From: Hayden Ausland
Sent: Thursday, December 10, 2020 10:58 AM
To: 'grluci@gmail.com'; Kim McMillan
Cc: 'JWLuci@gmail.com'; Tabitha Boschetti; Steve Koper
Subject: RE: Stormwater Master Plan - Public Comment Period

From: G Lucini <grluci@gmail.com>
Sent: Monday, December 7, 2020 3:43 PM
To: Hayden Ausland <hausland@tualatin.gov>; Kim McMillan <kmcmillan@tualatin.gov>
Cc: John Lucini <JWLuci@gmail.com>
Subject: Re: Stormwater Master Plan - Public Comment Period

I understand the City is providing a Citizen Comment period ending December 15th. And I understand the proposed Master Plan will then be presented to the Planning Commission, and then to the City Council for adoption into the City's governing documents.

Figure 4. Original County Subbasins - Erroneous Boundaries for Drainage above the Lucini Property.

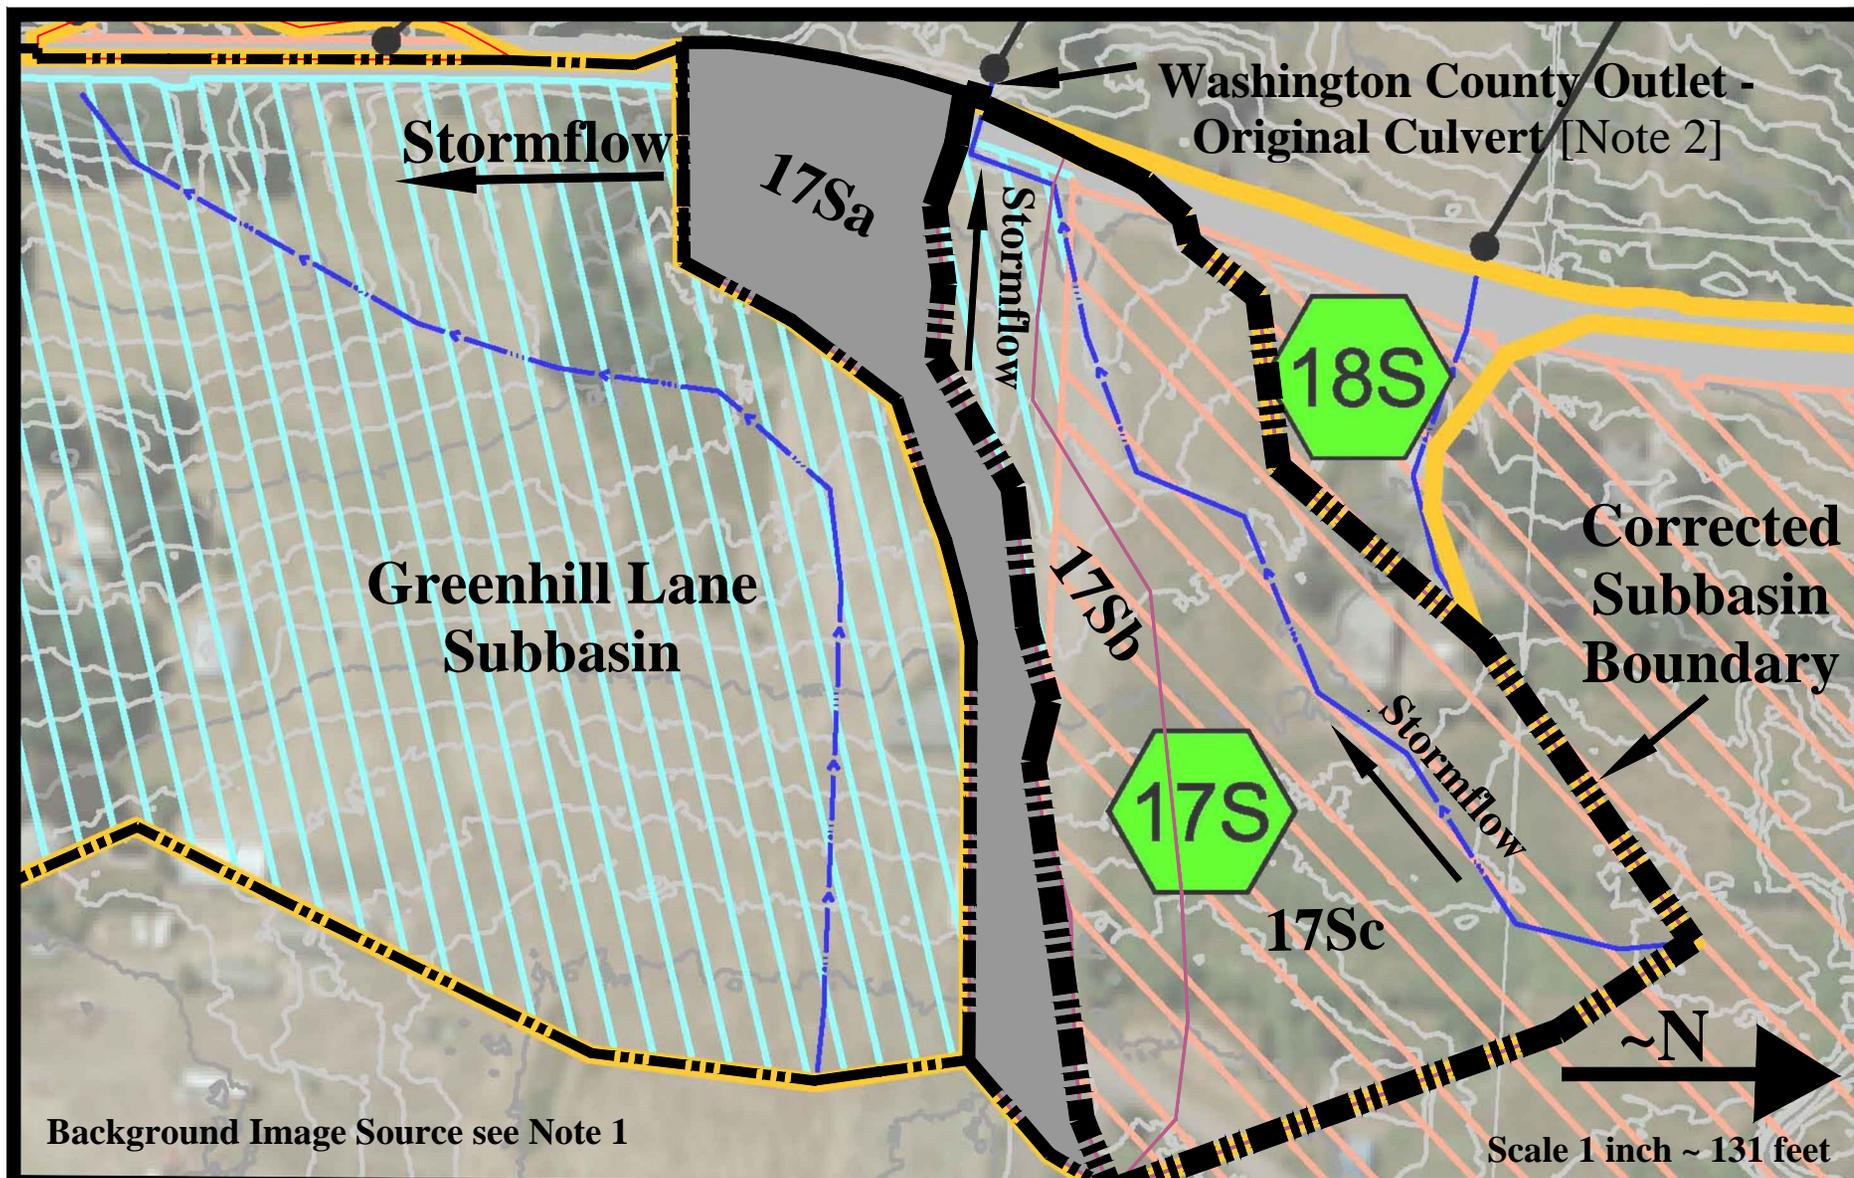
The hydrologic modeling considered a number of probable realistic cases unexamined in the Drainage Report for the 25-year design storm. The ORIGINAL subbasin configuration as depicted in Figure 4, which is corrected as shown in Figure 5. The hydrologic model was then run with the more accurate drainage area as the ORIGINAL subbasin configuration. This comparison demonstrates that the realistic (actual) peak flow value of 0.89 cubic-feet-second (cfs) discharging to the Lucini property is 31.5 percent less (see the Figure 6 column chart) than peak flow of 1.17 cfs claimed in the County's Drainage Report. This is critically important because the County is inflating the ORIGINAL stormflows and makes it seem like the ORIGINAL condition had higher flows. This is an adverse condition for the Lucini's because the Drainage Report analysis later claims to reduce the ORIGINAL stormflow amount that it previously inflated as part of the IMPLEMENTED project.

This resulted in erroneously concluding that the Boones Ferry Road right-of-way to the south of the original culvert¹³ flowed into the Lucini property. The actual Original subbasin excluded all of the rainfall runoff from the southern strip of the County’s wrongly depicted subbasin. This condition is illustrated in Figure 5, which more accurately shows the ORIGINAL stormflow from the southern strip as being routed to the Greenhill Lane subbasin.¹⁴

Figure 7. Increased Stormwater Peak Flows to the Lucini Property due to Ongoing Urban Land Use
Comparison based on Actual ORIGINAL Hydrologic Conditions - Prior to 2013

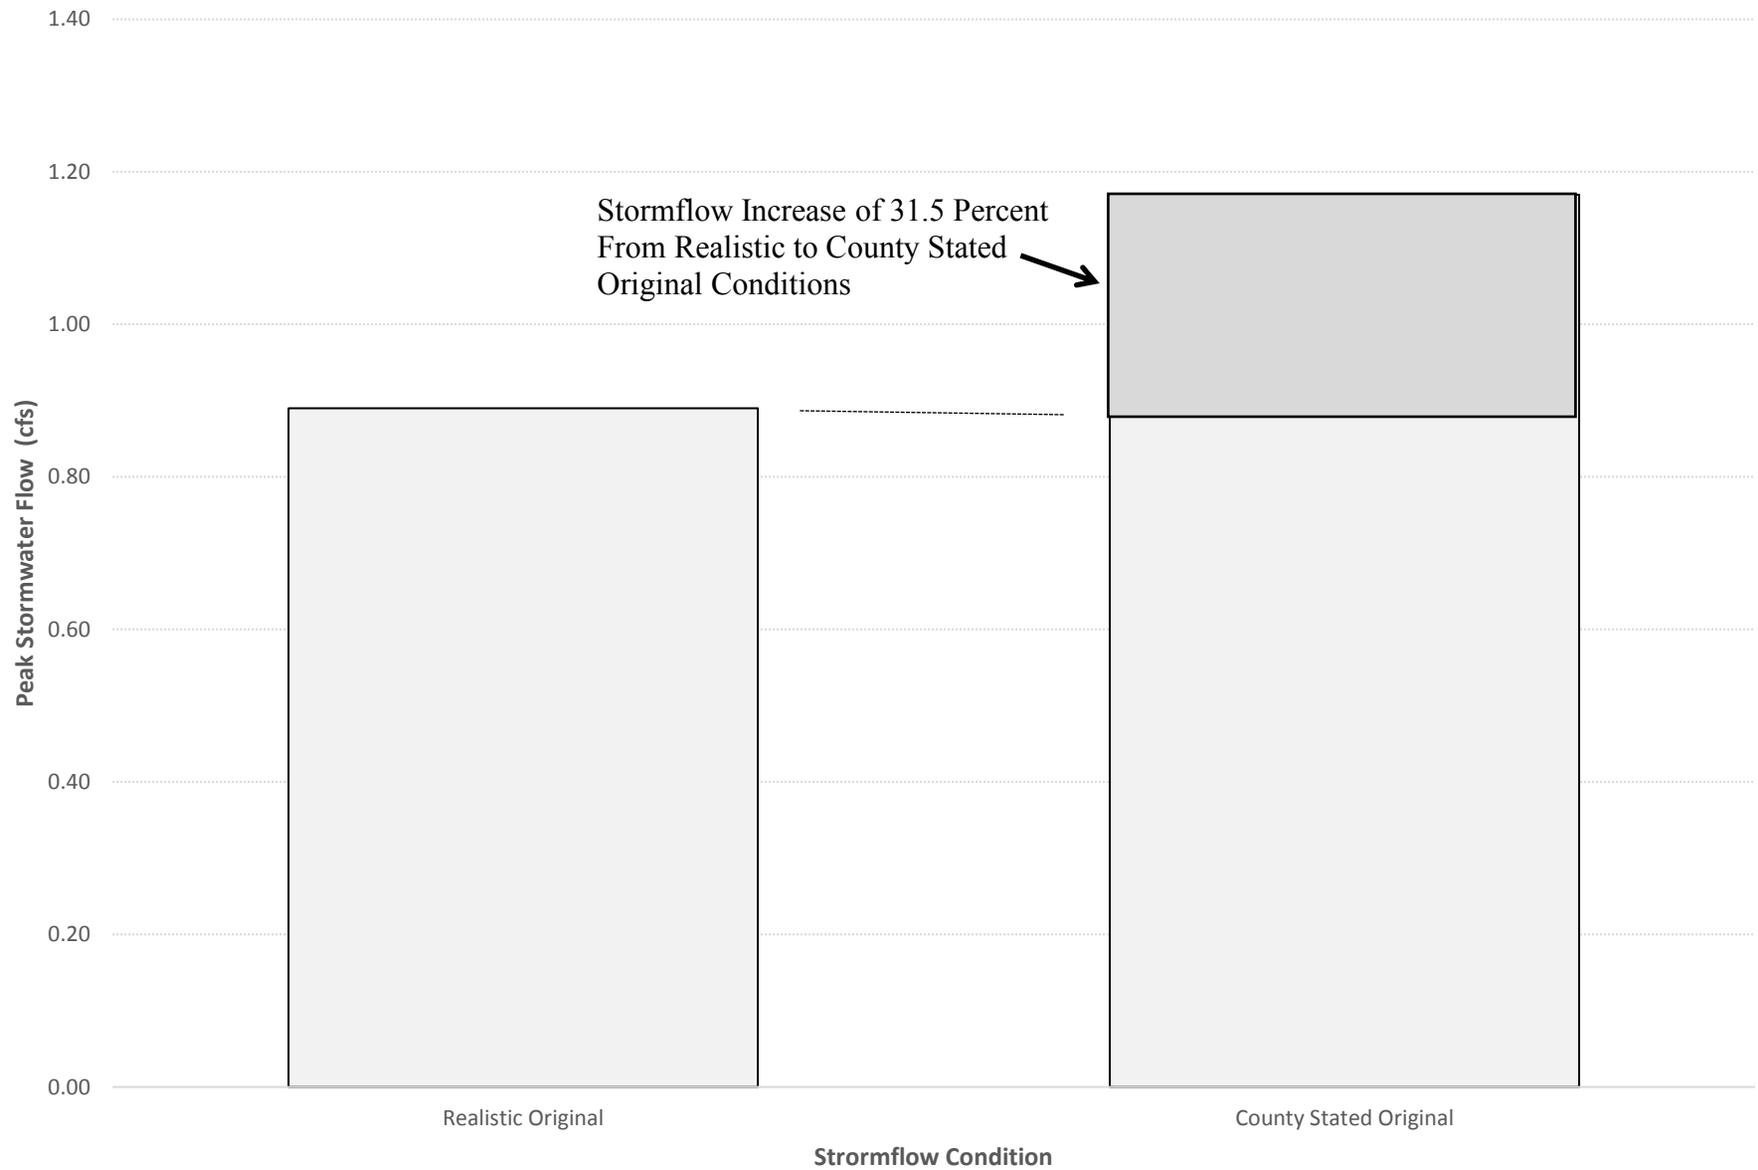
When realistic ongoing land use is considered, stormflows discharged to the Lucini property are projected to inflate to 92.1 percent of the ORIGINAL conditions (see middle column in Figure 7). When stormflows from ongoing land use are compared to IMPLEMENTED conditions, the Lucini property is projected to receive 204.7 percent of the realistic (actual) original stormflows based on implemented conditions (see middle column in Figure 8).

Figure 8. Increased Stormwater Peak Flows to the Lucini Property due to Full Build-Out Land Use
IMPLEMENTED (post-2015) Hydrologic Conditions Comparison to Actual Implemented Hydrologic Conditions based on pre-2013

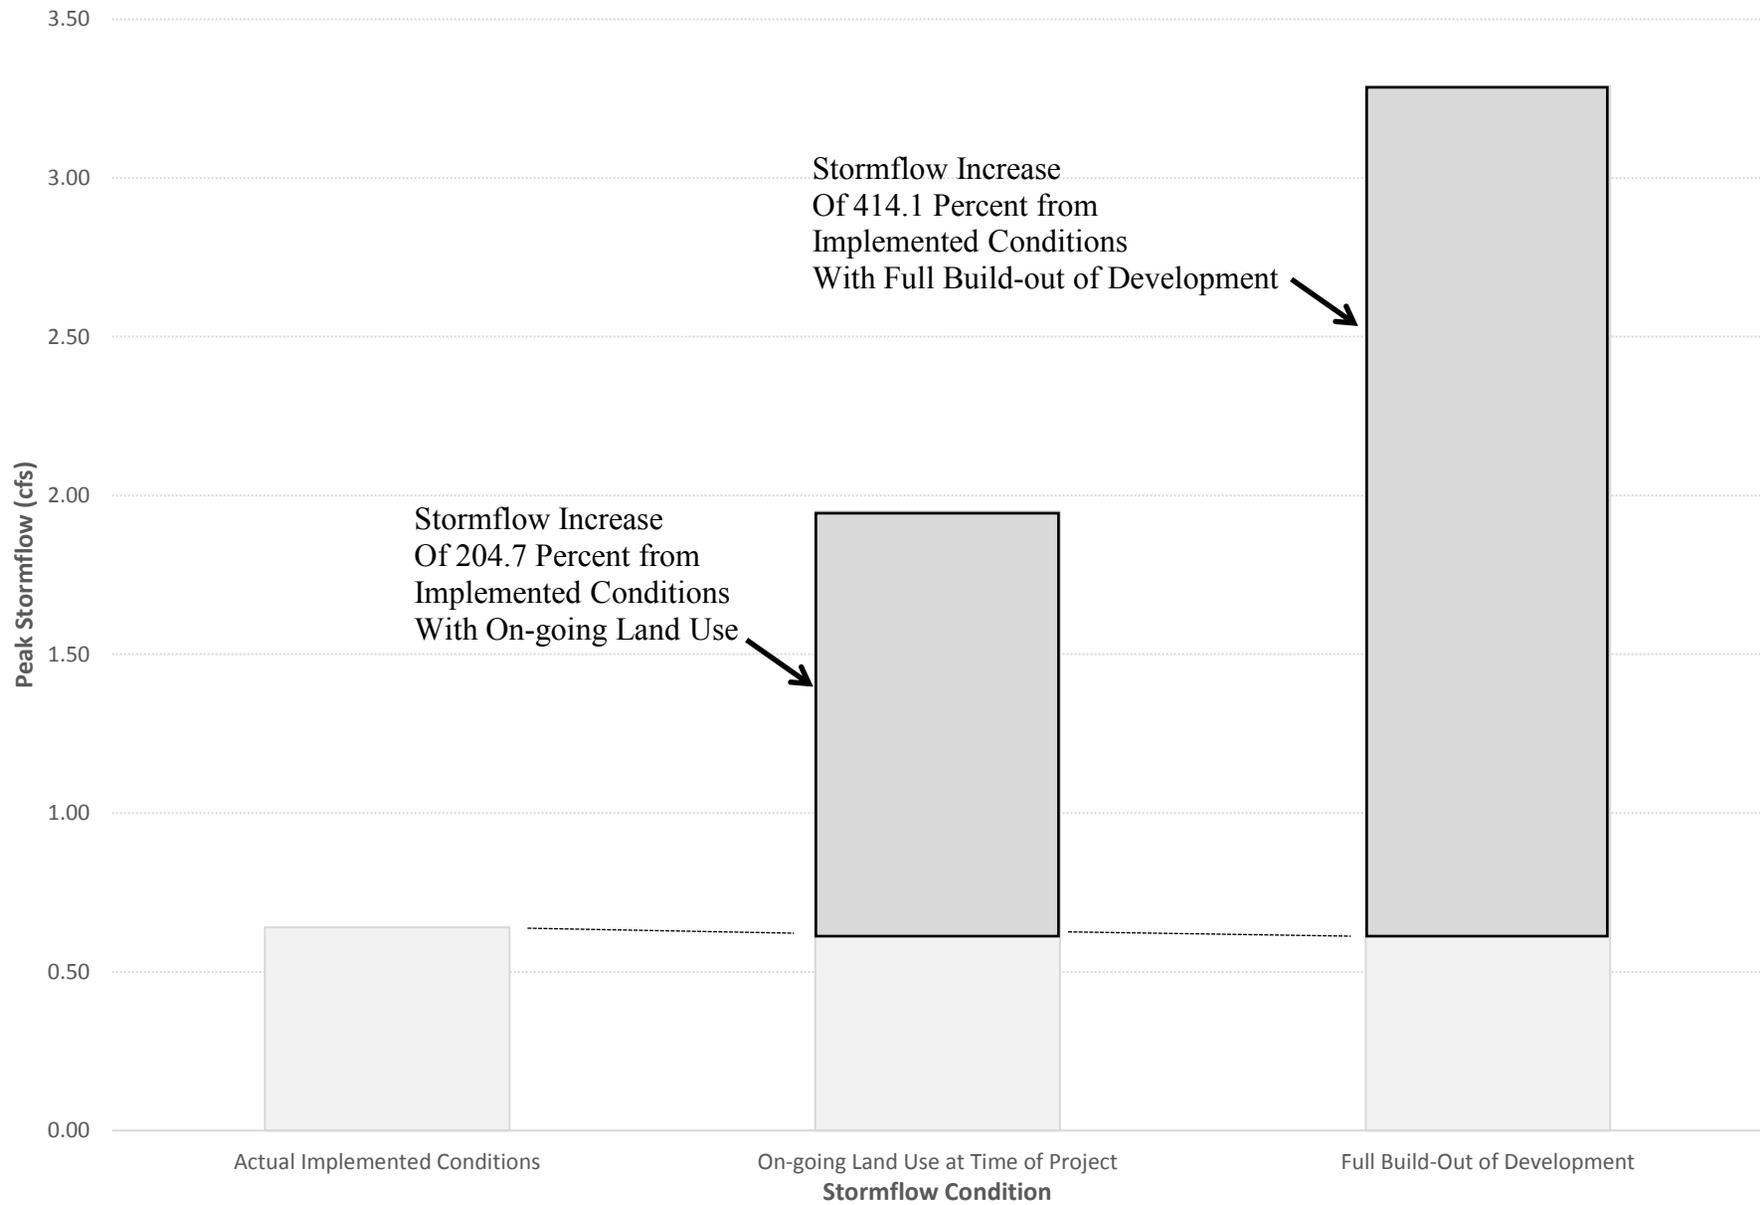
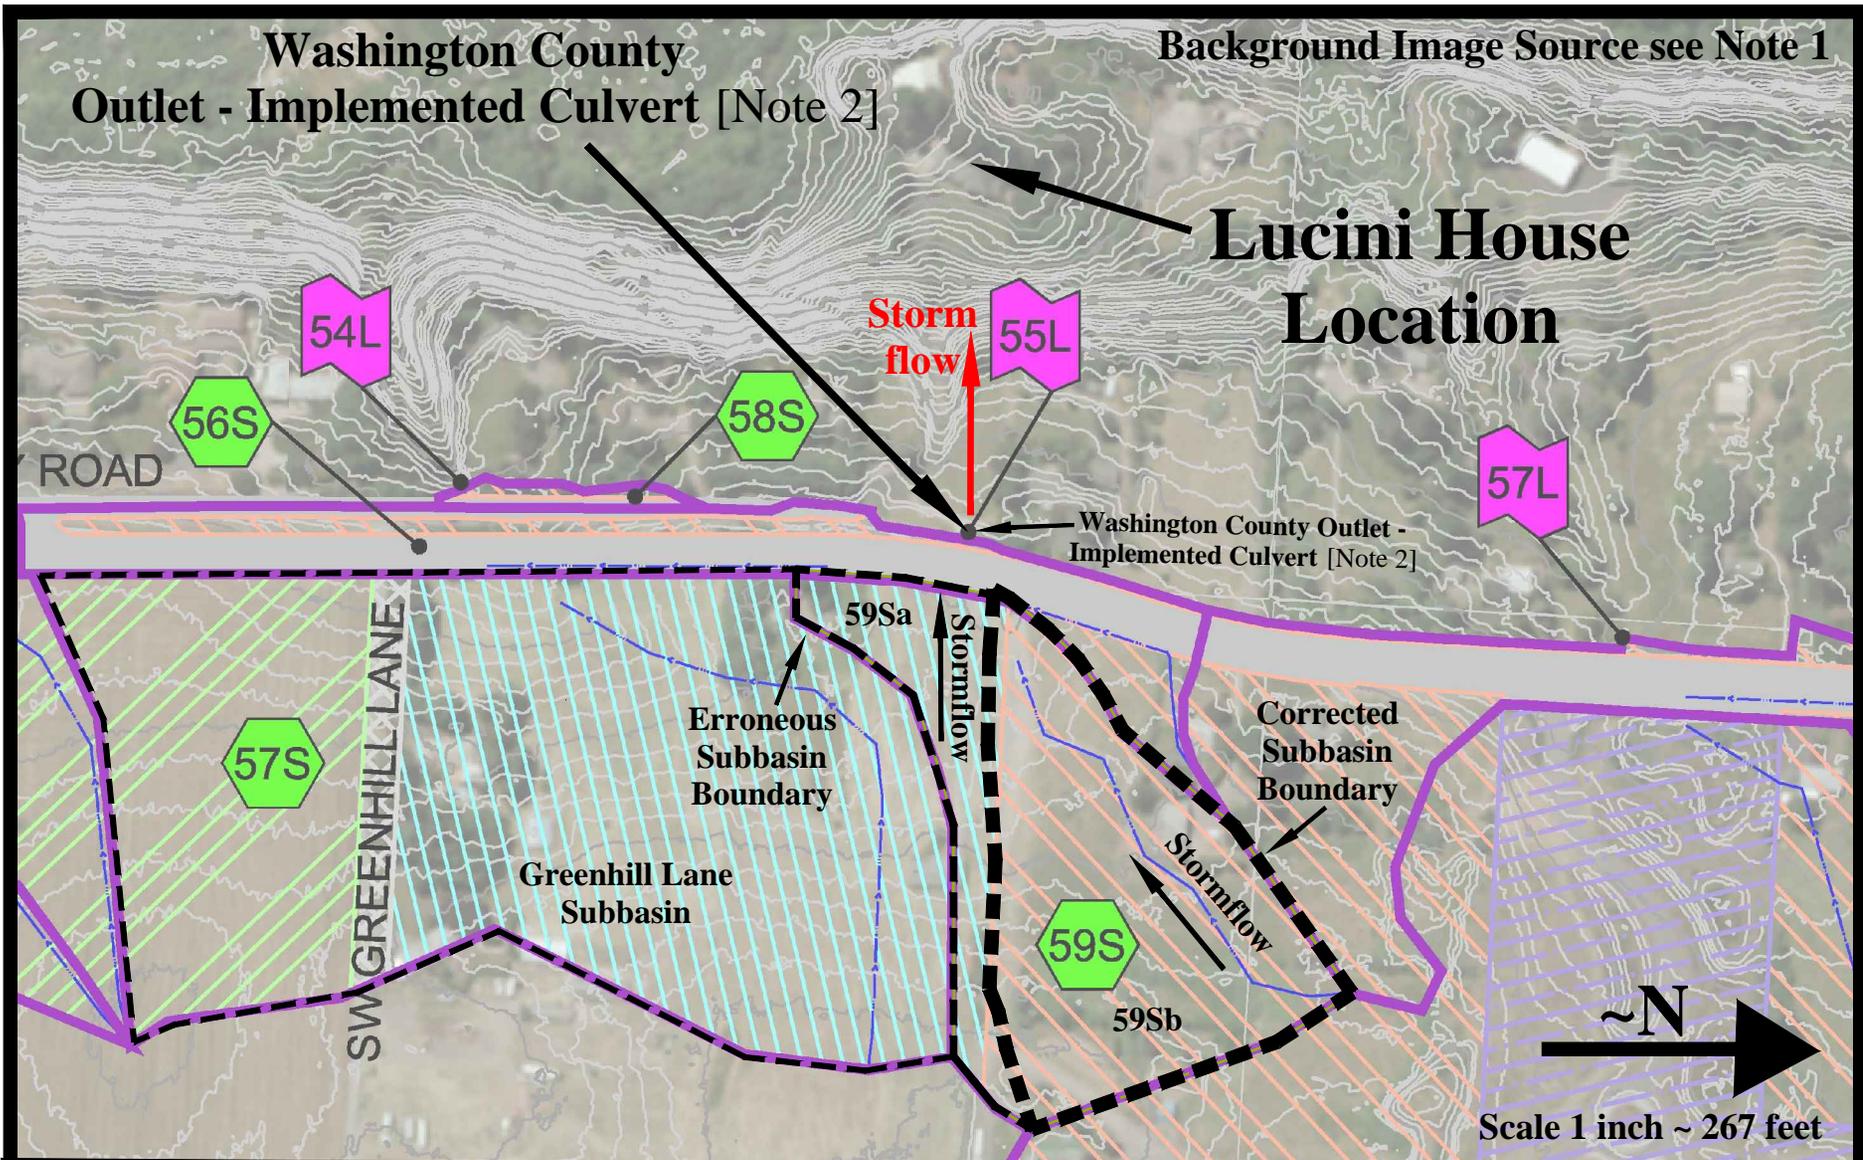
The majority of the subbasin above the Lucini property is slated for intense future development allowed within the 20-year future development (FD20) planning. The County disregarded this condition in its Drainage Report and is subjecting the Lucini property to significant burdens from future erosion and flooding. When realistic future full build-out development is considered, stormflows discharged to the Lucini property are projected to inflate to 220.2 percent of the ORIGINAL conditions (see right column in Figure 7). When stormflows from full build-out conditions are compared to IMPLEMENTED conditions, the Lucini property is projected to receive 414.1 percent of the realistic (actual) original stormflows based on implemented conditions (see right column in Figure 8).

The County did not consider future full build-out construction conditions slated for the drainage above the Lucini property. When this necessary evaluation based on the CWS guidance is considered, the County will be increasing storm flows to the Lucini property by about 220.2 percent.

As shown in the hydrologic and hydraulic evaluations in this report, ongoing urban development is already producing stormflows that exceed ORIGINAL conditions, by about 220 percent, that the Lucini property has historically been subjected to (see Figure 7). Urban development above the Lucini property, under full build-out conditions, pose a still greater threat. These stormflow projections exceed, by about 414 percent, the ORIGINAL stormflow conditions that the Lucini property has historically been subject to as depicted in Figure 8.
